RESPONSE TO REQUEST FOR ADDITIONAL INFORMATION

APR1400 Design Certification

RAI No.: 344-8407

SRP Section: 03.10 - Seismic and Dynamic Qualification of Mechanical and Electrical Equipment.

**Figure 6-11 High-Frequency Screening Process**

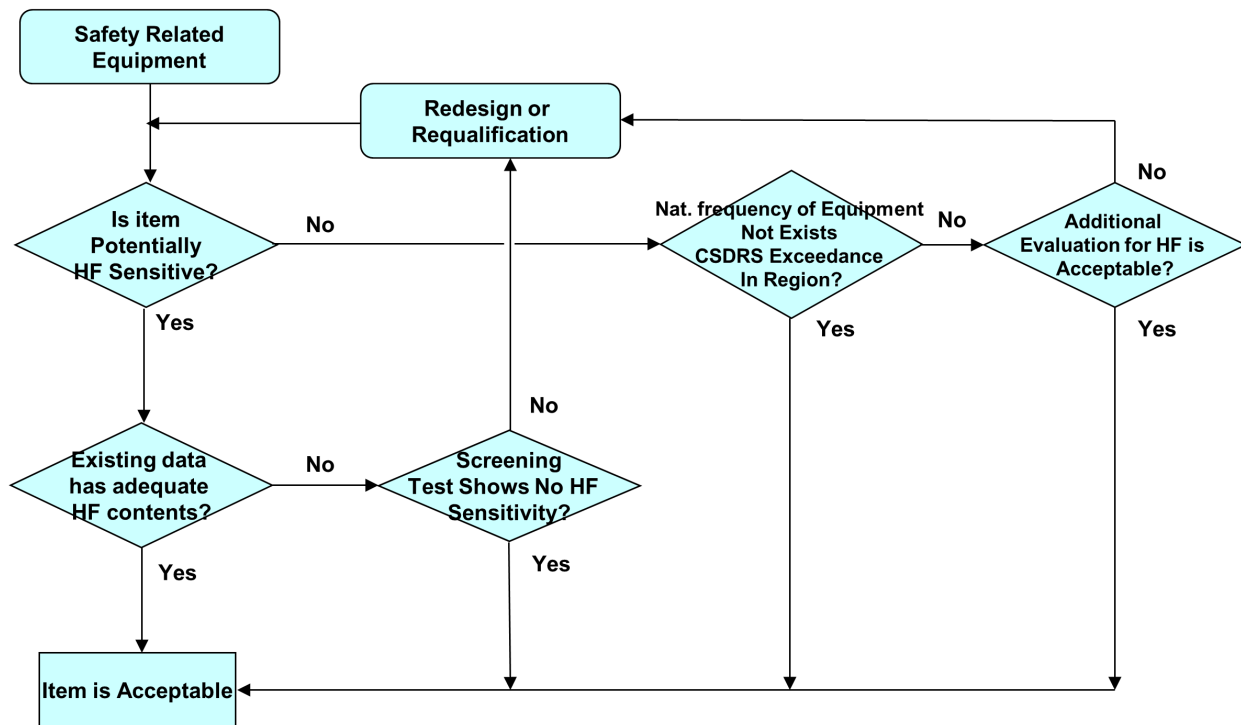
In RAI 8360 Question 03.09.03-4, the NRC staff requested that KHNP address how the hard rock high frequency ground motion response spectra exceedance of the certified seismic design response spectra discussed in DCD Tier2, Appendix 3.7B was considered in the evaluation of component dynamic qualification in other DCD sections including DCD Tier 2, Section 3.10, "Seismic and Dynamic Qualification of Mechanical and Electrical Equipment." DCD Tier 2, Appendix 3.7B.7.4 and Technical Report APR1400-E-S-NR-14004-P, "Evaluation of Effects of HRHF Response Spectra on SSCs," Revision 0, Section 6, "Evaluation," Subsection 1.18 "Safety-Related Equipment" state that safety-related equipment is evaluated for the effect of high frequency input motion for safety of the plant. However, the purpose and details of the evaluation are not clear.

Interim Staff Guidance DC/COL-ISG-01, "Interim Staff Guidance on Seismic Issues Associated with High Frequency Ground Motion," Section 4.0, "Identification and Evaluation of HF Sensitive Mechanical and Electrical Equipment/Components" provides guidance for the identification and evaluation of high frequency sensitive equipment. The guidance includes the need to provide a basis for the criteria used for each screening step that is used to identify equipment/components with potential for high frequency sensitivity, describe the process for evaluating the equipment and components that are screened in, and explain the method of generating the required response spectra at the location of support or attachment point.

To the extent that Technical Report APR1400-E-S-NR-14004-P and the information presented in DCD Tier 2, Appendix 3.7B is proposed to be approved as part of the design certification application (information on which was requested in RAI 8360 Question 03.09.03-4), the NRC staff requests that KHNP describe the evaluation process fully and provide the information discussed in DC/COL-ISG-01, and update the DCD and technical report.

The process for evaluating exceedance of the certified seismic design response spectra with respect to hard rock high frequency ground motion response spectra and the effects on the dynamic qualification of components is provided in the attached description. The described process includes the information discussed in DC/COL-ISG-01 and will be incorporated into Technical Report APR1400-E-S-NR-14004-P/NP, "Evaluation of Effects of HRHF Response Spectra on SSCs," Revision 1, Subsection 6.4 "Safety-Related Equipment" and into DCD Section 3.7B.7.4 "Safety-Related Equipment."

Identification and evaluation process of HF sensitive mechanical and electrical equipment and components is performed for safety-related equipment and components before performing seismic qualification. Refer to Figure 6-11 for the High Frequency Screening Process.
